# TOWN OF UNDERHILL

## Development Review Board

JASON A. & KAREN M. GUYMON AND  
ANTOINE M. & PAMELA J. CATUDAL  
PRELIMINARY & FINAL SUBDIVISION REVIEW  
Docket #: DRB-19-08

<b>Project Proposal:</b>	Preliminary & Final Subdivision Review of Jason A. & Karen M. Guymon and Antoine M. & Pamela J. Catudal for a proposed 2-Lot Subdivision of property located at the aforementioned address.
--------------------------	---

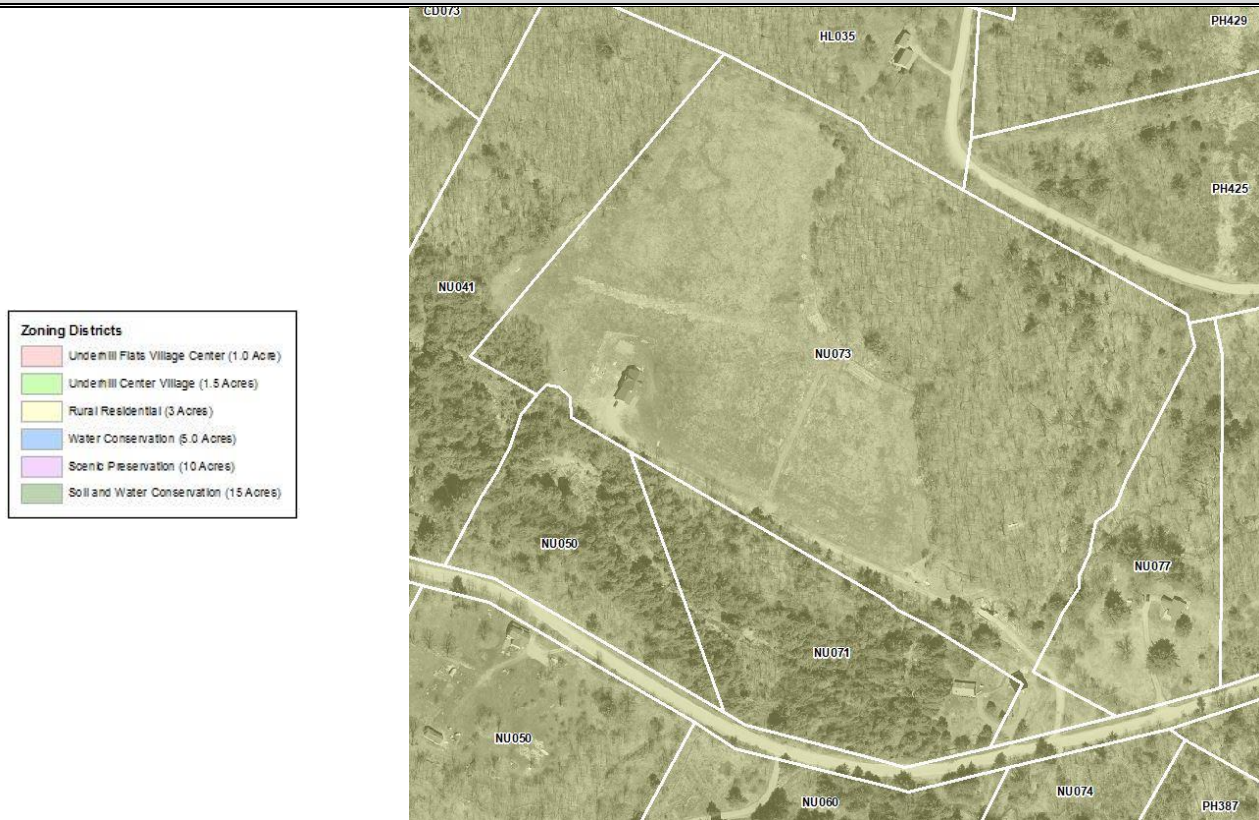
1. **SECTION 3.2 – ACCESS:** Lot 1 fails to satisfy the frontage require; however, the frontage requirement can be waived in accordance with §§ 3.7.E.1 & 8.6.A.2 since the lot will be accessed by a shared driveway.
2. **SECTION 3.18 – SLOPE:** The Board should determine if additional review under this section is required, as the shared driveway will need to be widened to 14 ft. If the widening of the driveway will occur on land that is under 15% slope, then no further review under this section is required.

3. **SECTION 7.3 – SKETCH PLAN REVIEW, CONDITION 1:** The submitted site plan and submitted plat both depict streams/brooks; however, do not depict any wetlands.

4. **SECTION 7.3 – SKETCH PLAN REVIEW, CONDITION 7:**
    - a. The Applicants are proposing a turning radius of 28 ft. at the intersection of the two driveways.

- b. Information regarding the turning radii at the intersection of the shared driveway and North Underhill Station Road has not been provided.
  5. **SECTION 7.3 – SKETCH PLAN REVIEW, CONDITION 9:** Draft deeds containing, or making reference to the shared right-of-way serving Lot 1 and wastewater easement serving Lot 2 have not been provided.

- **SECTION 8.2.G – BUILDING ENVELOPES:** The Applicants have identified a proposed building envelope for the proposed Lot 2, which is more restrictive than the Rural Residential District allows. While more restrictive, the building envelope has been reduced in size in order to protect forested areas on the proposed Lot 2.

6. **SECTION 8.8 – LEGAL REQUIREMENTS:** A deed containing a draft septic easement for the benefit of Lot 2 has not been provided.
  7. **APPENDIX A – ROAD & DRIVEWAYS STANDARDS, SECTION 4.C.3:** The Applicants have not provided information regarding the turning radii of where the shared driveway will meet North Underhill Station Road. The Board should consider a condition of approval regarding the turning radii at this intersection if they find this intersection needs to be brought up to the standards within the Road Ordinance.

### **SECTION 3.18 – STEEP SLOPES**

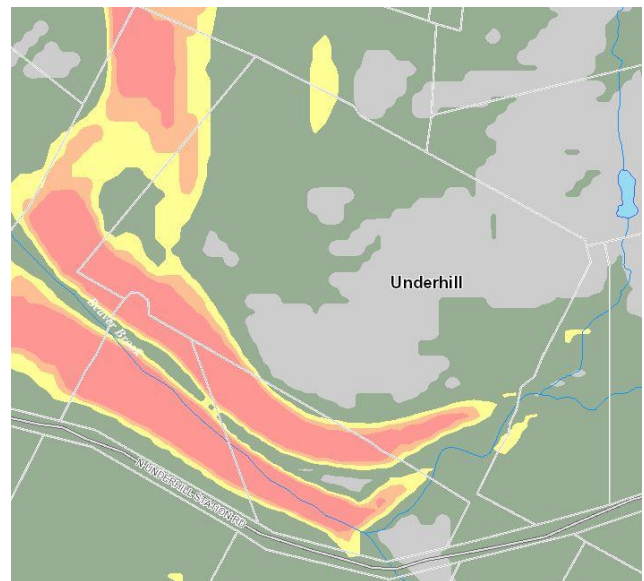
- Areas of steep slopes (15-25%) are present on the existing lot (see directly to the right).
  - Steep Slopes (15-25%) and Very Steep Slopes (>25%) appear to affect both lots; however, the proposed/existing developments (single-family dwellings) appear to be outside of these areas.
- Since both driveways are already constructed, no significant additional impact to these areas is anticipated.
  - The Board should determine if additional review under this section is required, as the shared driveway will need to be widened to 14 ft.
    - If the Board finds that the widening of the driveway will occur on land that is under 15% slope, then no further review under this section is required.

### SECTION 3.19 – SURFACE WATERS & WETLANDS

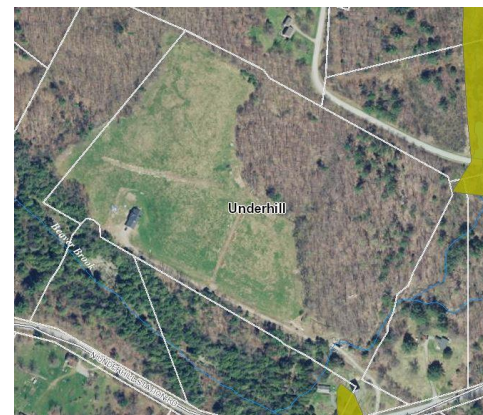
- An unnamed stream bisects the southern portion of the lot in an east to west direction (see directly to the right) – 25 ft. Setback Requirement.
- Beaver Brook is located to the south of the property; A 50 ft. Setback from the “top of slope” is required since no floodplains are associated with the Brook in this location.
- A Class II Wetland has been identified to the northeast of the property, as well in the south portion of the property – 50 ft. Setback Requirement.
- All anticipated new development is expected to satisfy the aforementioned setback requirements for wetlands and surface waters.
